NCSX SPECIFICATION

General Requirements Document (GRD)

NCSX-ASPEC-GRD-06-dE

June 27, 2008

Figure 3-2 NCSX Coordinate System

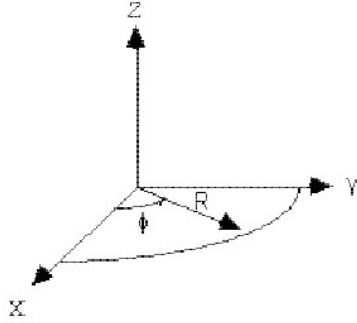
Updated Figure 3-2 per Nelson comment (cosmetic change only).
